Additional information

Planning Committee

Wednesday, 12 January 2022, 6.00pm

**PC2201-1 EDMUND STREET, NO. 151 (LOT 2) BEACONSFIELD - ADDITIONS
(TWO STOREY) TO EXISTING SINGLE HOUSE (TG DA0310/21)**

151 Edmund Street, Street view, Googlemaps, 17/08/2021

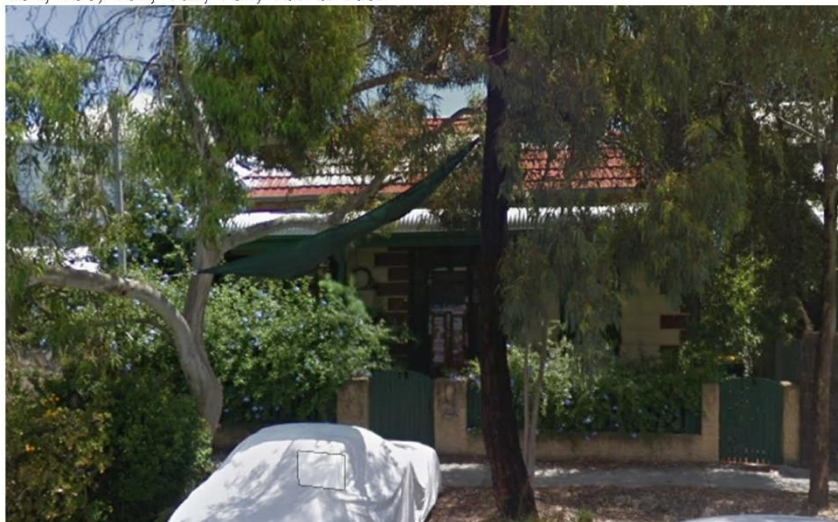
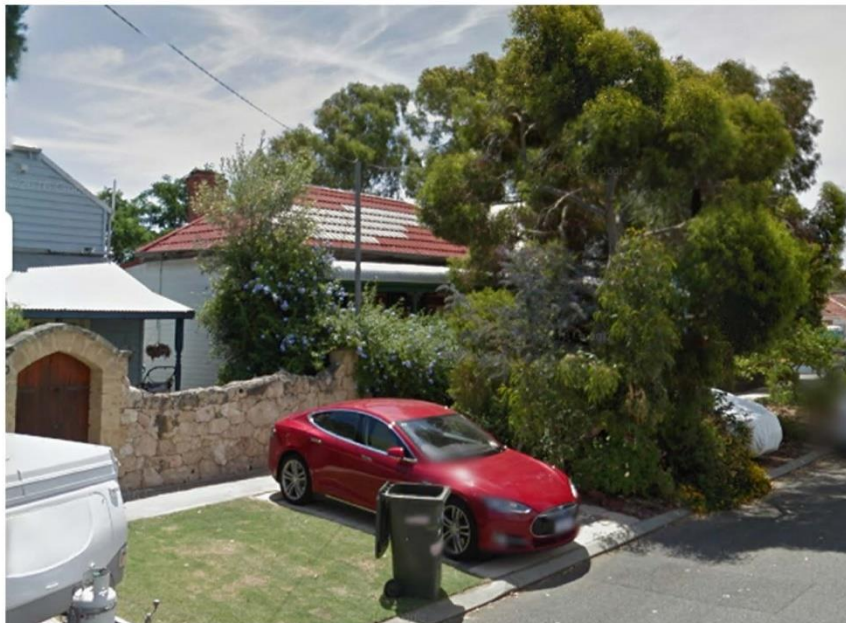
The proposed two storey addition is constructed over the original part of the building and will have an impact on the place itself and the streetscape. This is not in accordance with current Local Planning Policies.

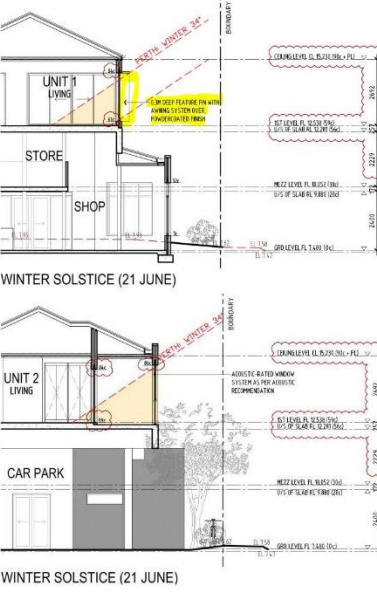
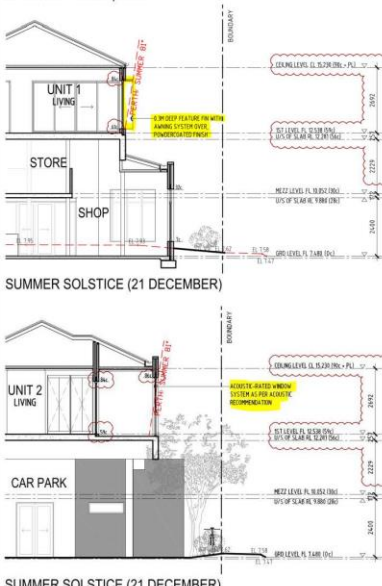
ELEMENT 4.1	SOLAR AND DAYLIGHT ACCESS	
ELEMENT OBJECTIVES <i>Development is to achieve the following Element Objectives</i>	APPLICANT COMMENT	ASSESSOR COMMENT
<p>O4.1.1 – In climate zones 4, 5 and 6: the development is sited and designed to optimise the number of dwellings receiving winter sunlight to private open space and via windows to habitable rooms.</p>	<p><i>Compliant with Acceptable Outcomes.</i></p>	<p>Apartments have good sunlight access given the balconies and habitable rooms face (or have access to) the northern aspect of the site. Applicant provided diagram below to illustrate this point:</p>

<p>O4.1.2 – Windows are designed and positioned to optimise daylight access for habitable rooms.</p>	<p><i>Compliant with Acceptable Outcomes.</i></p>	<p>Complies – as noted below, the presence of the fins at the northern windows allows for adequate winter sunlight access, whilst minimising summer sunlight incursion.</p>
